RS-21-009

LaSalle County Station, Units 1 and 2  
Renewed Facility Operating License Nos. NPF-11 and NPF-18  
NRC Docket Nos. 50-373 and 50-374

Subject: Response to Request for Additional Information Regarding the License  
Amendment Request to Adopt 10 CFR 50.69 (EPID L-2020-LLA-0017)

Figure 2-3  
Seismic Correlated Failure Assessment

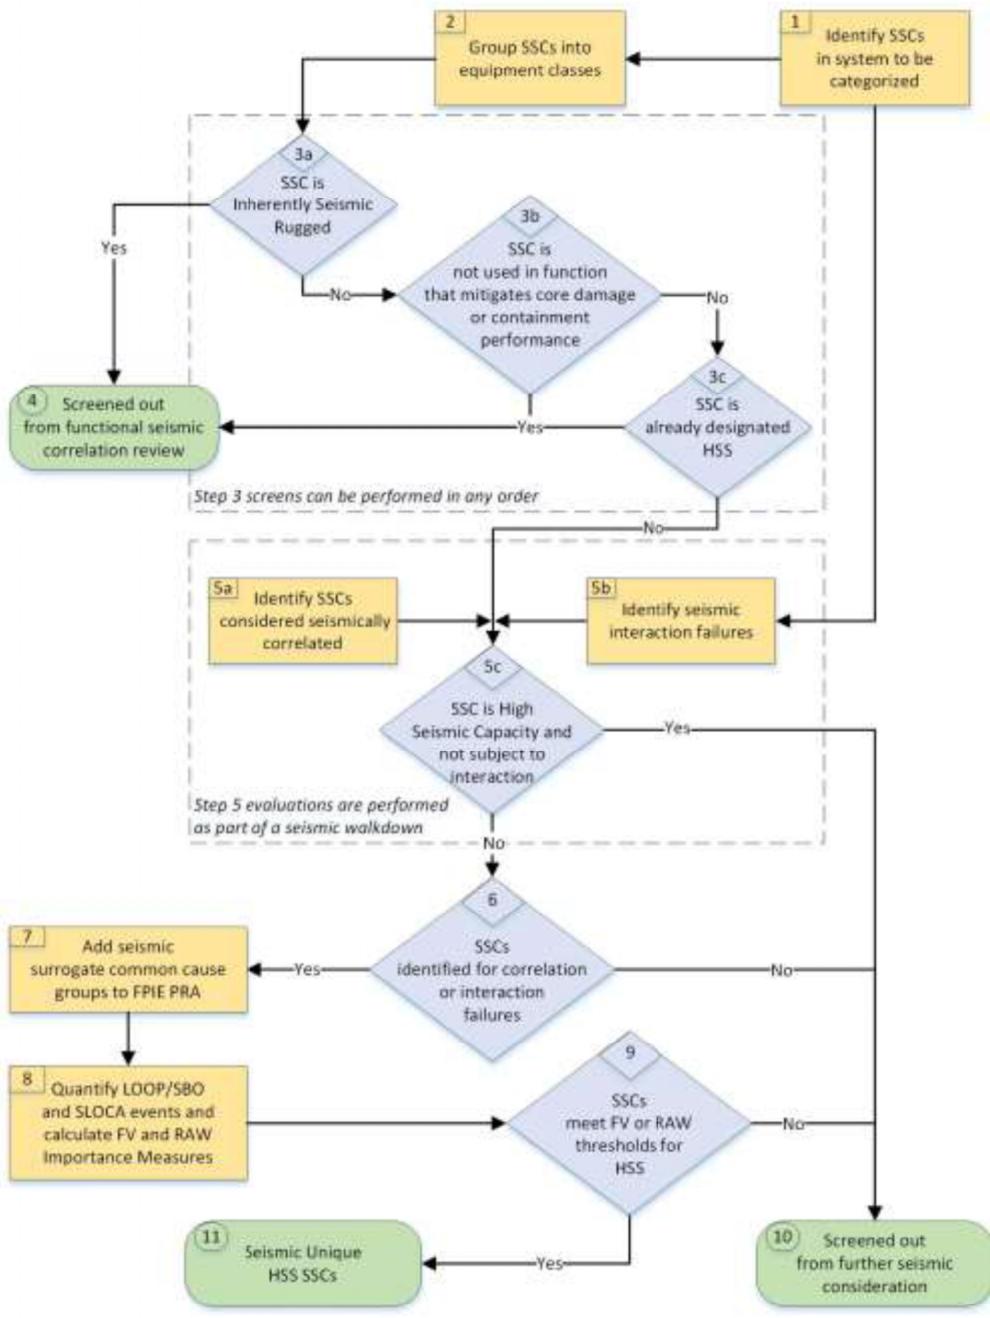
**Commented [RJ8]:** RAI Response 4f

**Commented [RJ9]:** Text added as part of Second Round RAI response 4F-01

**Commented [RJ11]:** Remove this text as part of Second Round RAI 4E-01b

- b. **Assess potential seismic interactions to identify conditions that could fail multiple components in the system. [Also include single component failures in the system due to either seismic interaction or direct component failure modes, that result in total loss of a multi-train system and where there is not another system that independently provides the same function].** Guidance for this seismic interaction walkdown review is also contained in Appendix A.

6. **SSCs that are determined through the walkdown to be of high seismic capacity and not included in seismically correlated groups or correlated interaction groups can be screened out from further seismic considerations since their non-seismic failure modes are already addressed in the FPIE PRA and fire PRA. Those remaining components identified in Step 5 with seismic correlated failures or seismic interaction failures of multiple components proceed forward for inclusion of associated seismic surrogate events in the Tier 2 adjusted PRA model.**
